STAFF REPORT

TO: Bicycling, Transportation, and Street Safety Commission

SUBJECT: West Davis Active Adult Community – Preliminary Comments

AGENDA ITEM #6A
West Davis Active Adult Community

Figure 2: Conceptual Master Plan

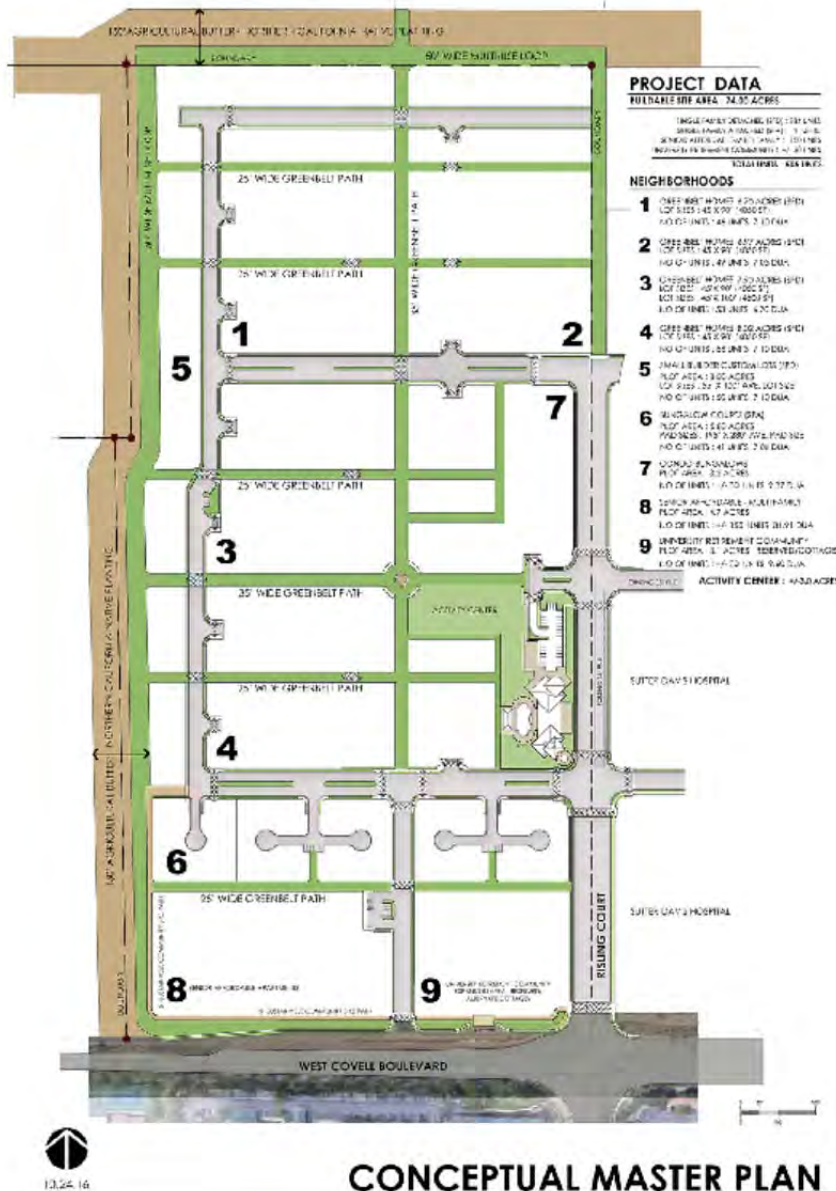
Greenbelt widths are discussed in the following section. With respect to on-street bicycle facilities, staff notes that seven-foot bicycle lanes are proposed on the main north-south and east-west segments (shown in yellow, above), while the smaller residential streets would have a shared ten-foot travel lane in each direction, plus on-street parking. On-street connections to the northeast portion of the site are circuitous but do provide options for the rider.

The preliminary concept plan shows greenbelts of 25-35 feet throughout the project, no public park, and an HOA-maintained outdoor area as part of the Activity Center.

Staff feels that the preliminary site plan could be improved with the addition of greater connectivity and loop streets, similar to the concepts illustrated in Figure 2 of the General Plan Transportation Element (below). Interconnectedness will accommodate vehicles for emergency services and waste removal, and improve “permeability” and resident access throughout the neighborhood.

The preliminary site plan also shows multiple flag lots at the ends of the cul-de-sacs. These lots can require frequent curb cuts, which can create difficulty for placement of street trees, on-street parking, and waste collection. The driveways for the flag lots might also pose challenges for senior citizen residents.

Figure 5 - 35' Multipurpose Pathway (Central Spine)

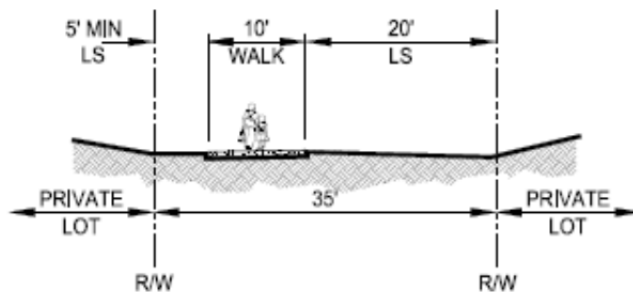
The General Plan calls for greenbelts averaging 100 feet wide. Recently-adopted street standards call for multi-use paths to be 12 feet wide, with 2 foot rideable/walkable shoulders, for a total of 16 feet of rideable surface (FHWA guidelines and Shared-Use Path LOS analysis can be used in determining appropriate path width to maximize LOS without overbuilding infrastructure).

Staff feels that a central greenbelt could serve as the pedestrian/bicycle circulation corridor and public green space for subdivision residents, but it would need to be of appropriate width to accommodate a variety of uses, including activity nodes that might include uses such as play structures, outdoor exercise equipment, and/or a fenced play area for small dogs. The variety of potential users, including cyclists, persons with mobility impairments, parents with babies and strollers, and other users are likely to require wider-than-proposed paths to reduce potential for conflicts.

Figure 6 - Covell Boulevard Street Section

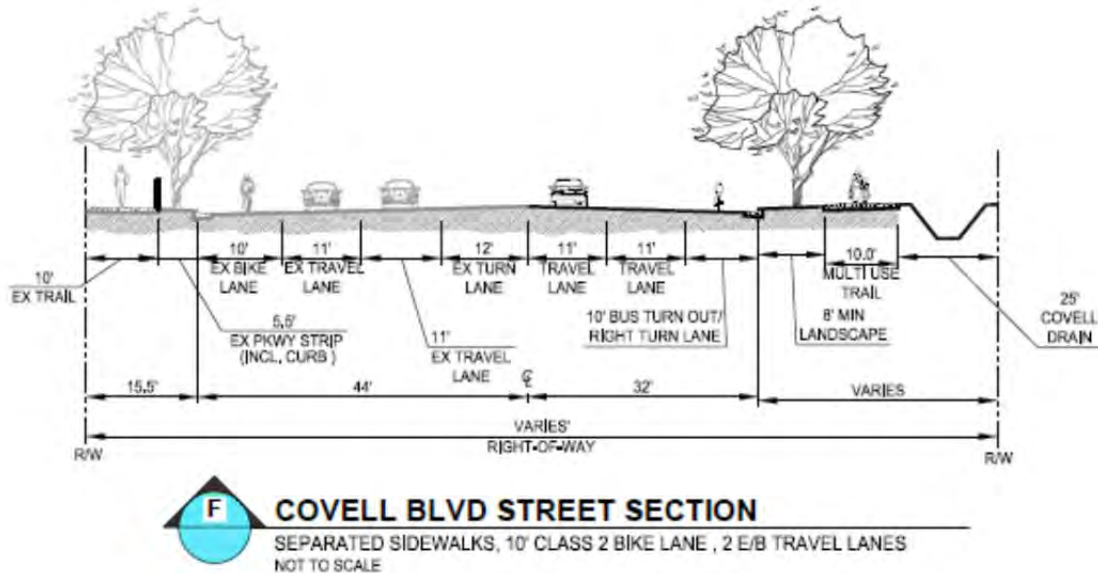
Staff notes that the proposed eleven-foot travel lane exceeds the newly-adopted standard of ten feet, and the ten-foot multi-use trail on the north side of Covell is less than the new standard of twelve feet.

Figure 7- Covell/Risling/Shasta Intersection

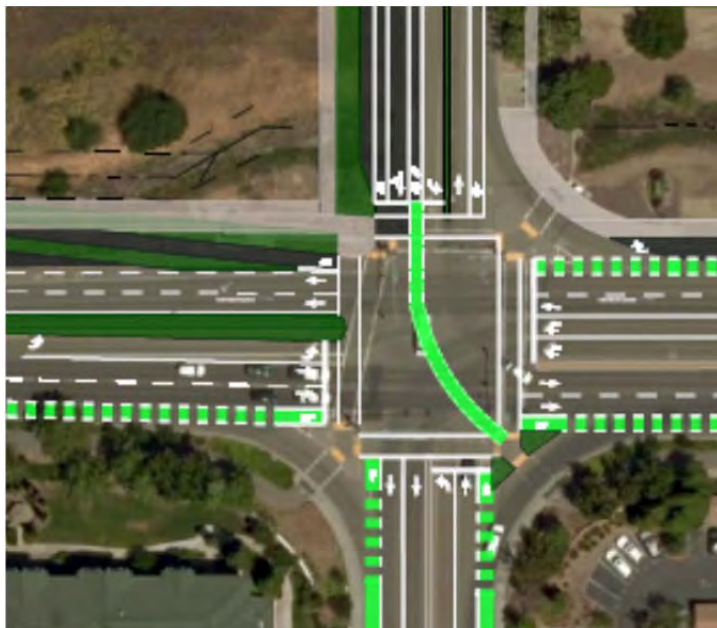
The General Plan Circulation Element includes an action bullet to “Eliminate intersection standards that allow high speed right turns for motor vehicles.” Staff and the applicant are working to evaluate options for the free right turns at the intersection of Covell with Shasta and Risling to improve safety for pedestrians and vehicles while addressing vehicle circulation patterns, particularly from northbound Shasta to eastbound Covell.

2 LANE STREET SECTION (EXISTING RISLING COURT)

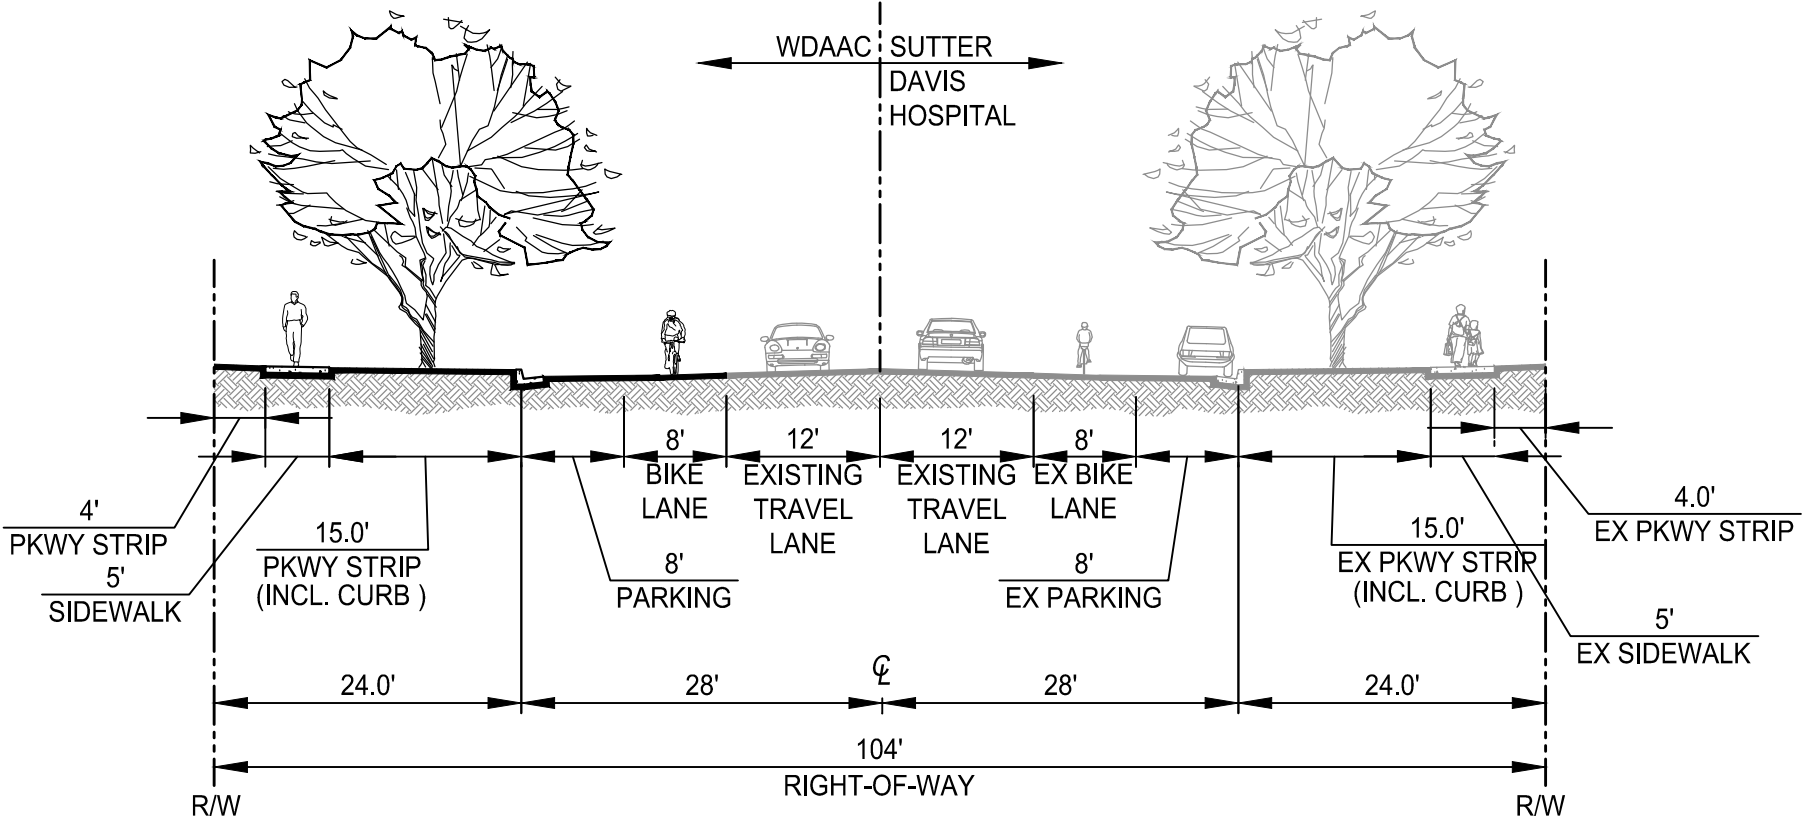
Attachment 3 contains proposed street sections for the subdivision. These plans show 4-foot parkway strips on two sections, Section C and Section D (Risling). Based upon staff review and comment, these sections will be changed to include a 6' sidewalk and 6' parkway strip on the WDAAC side of Section C, and 6' parkway strips on Section C with space freed by reducing the median from 12 to 8 feet.
